9.2 NO. 17 (LOT: 11; D/P: 2447) ST ALBANS AVENUE, HIGHGATE - PROPOSED ALTERATIONS AND ADDITIONS TO SINGLE HOUSE

That Council, in accordance with the provisions of the City of Vincent Local Planning Scheme No. 2 and the Metropolitan Region Scheme, **APPROVES** the application for Alterations and Additions to Single House at No. 17 (Lot: 11; D/P: 2447) St Albans Avenue, Highgate, in accordance with the plans shown in Attachment 2, subject to the following conditions, with the associated determination advice notes in Attachment 7:

E04
A02 **ELEVATION 04 - NORTH WEST** 1:100

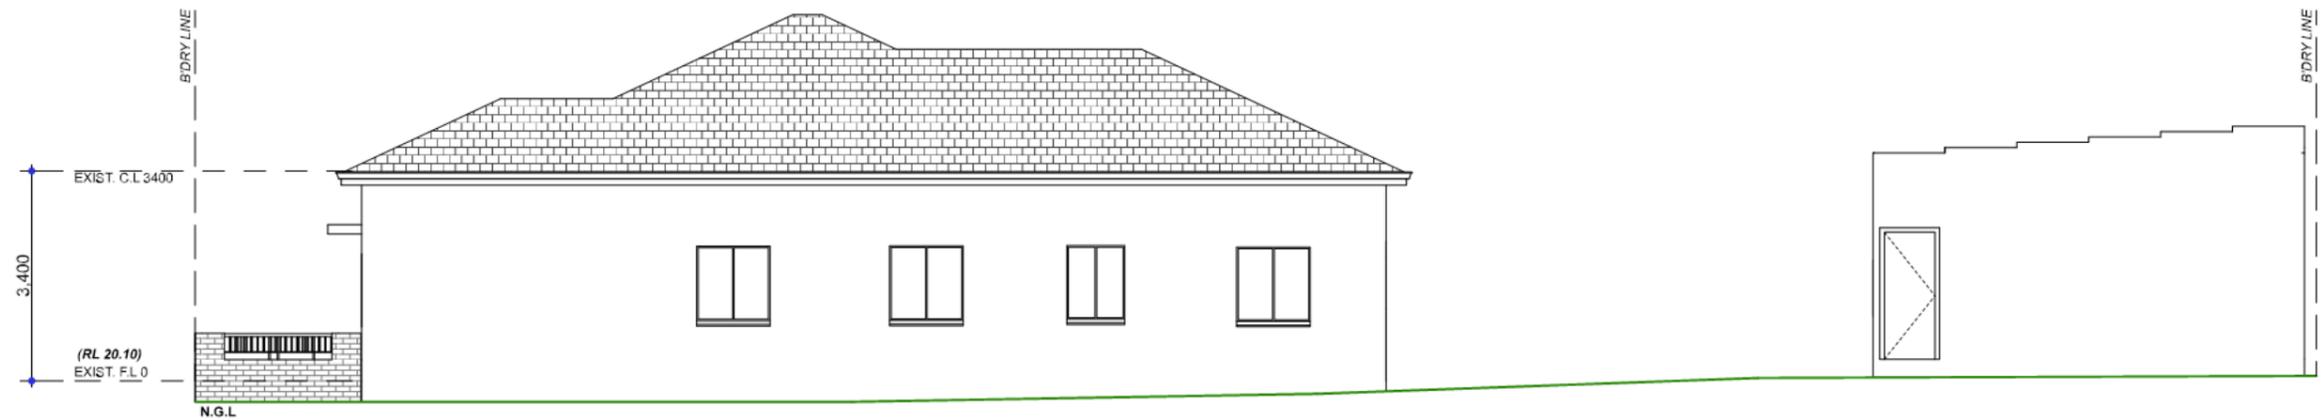
- Concerns regarding survival and long term effectiveness of the proposed green wall as a method of reducing the bulk and scale of the two storey brick wall abutting the ROW to the north west. Recommendation that further articulation of this wall be provided to reduce bulk and scale;

- Reducing the overall height of the two storey brick wall abutting the ROW to the north west from 7.3 metres to 6.5 metres and replacing the proposed green wall with feature projecting brickwork;

- The reduction in overall height of the two storey brick wall and the additional feature brickwork rather than the green wall provides further articulation to reduce the bulk and scale;
- The change of the existing dwelling rendered brick to a light grey is more in keeping with the tones of the streetscape; and
- The change of front fence colour from white to dark grey is more consistent with the streetscape and is appropriate.

PROPOSED ROOF TERRACE FLOOR PLAN
1:100

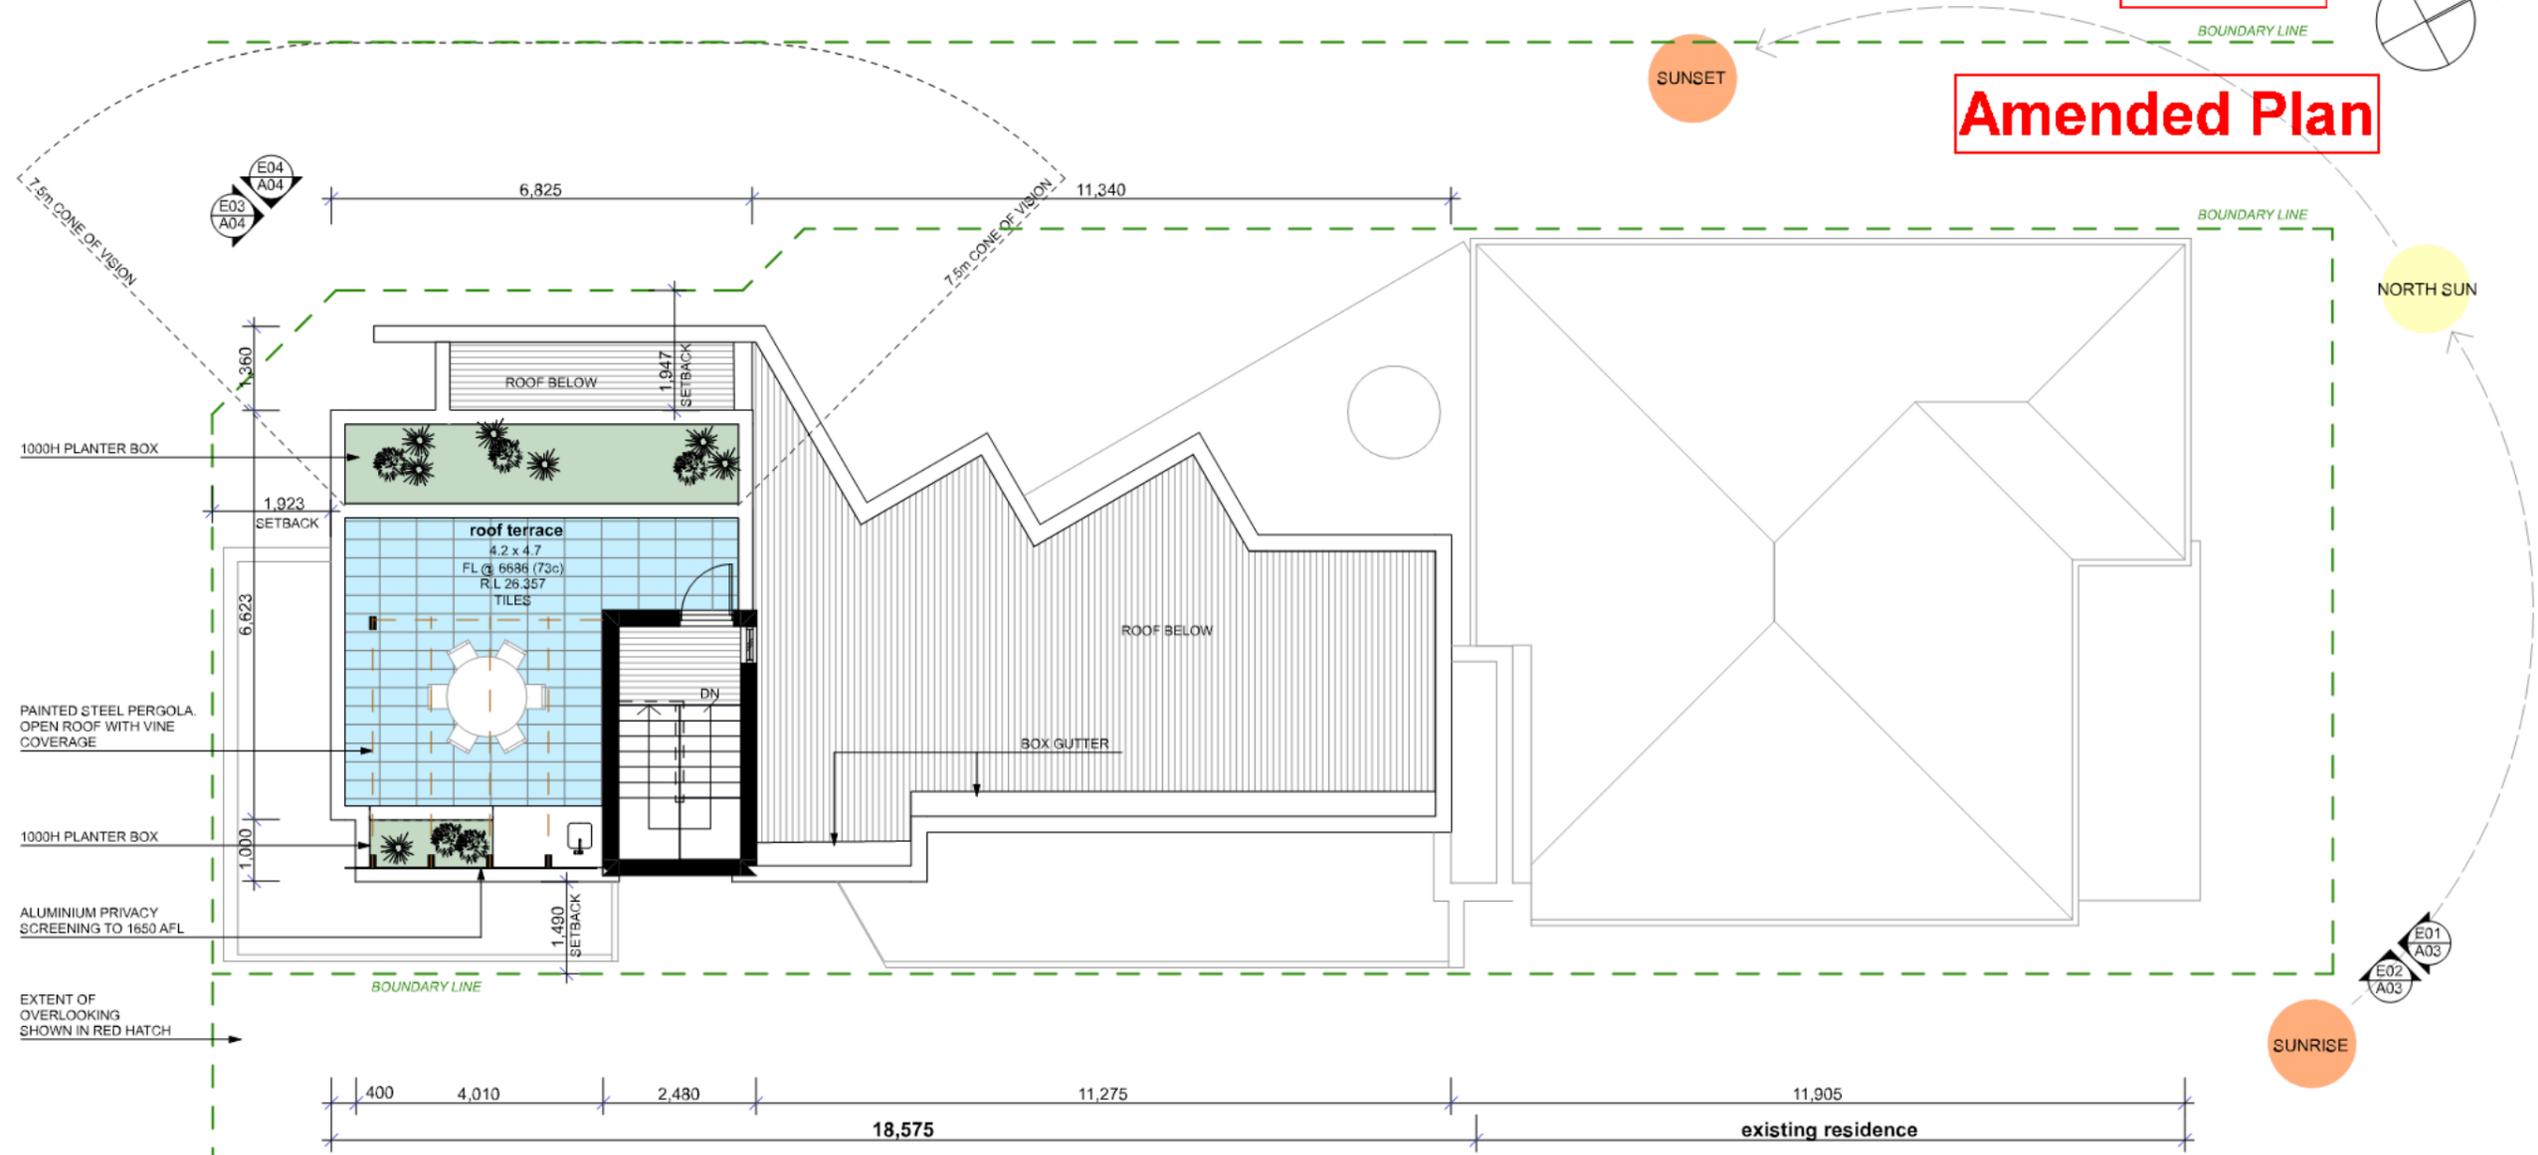
Privacy screening shall be extended for the full length south eastern edge of the roof terrace. The privacy screening shall have a height of 1.6 metres above the floor level of the roof terrace to satisfy the deemed-to-comply provisions of the Residential Design Codes Clause 5.4.1 – Visual Privacy in relation to the property to the south east (refer to advice note 13).

- The applicant is proposing a 1.5 metre wide built in planter box with a depth of 1.0 metre to the north western edge of the rooftop terrace. This planter would effectively increase the setback of the terrace from 6.0 metres to 7.5 metres. Further to the physical setback that this planter box would provide, it would also serve as a screening device to restrict the vertical cone of vision and limit the ability to look down into the rear backyards of the adjoining properties on the opposite side of the ROW, making any views oblique rather than direct. Should the application be approved, it is recommended that a condition be imposed requiring this planter box to be installed prior to occupation and not be removed unless further planning approval is granted;
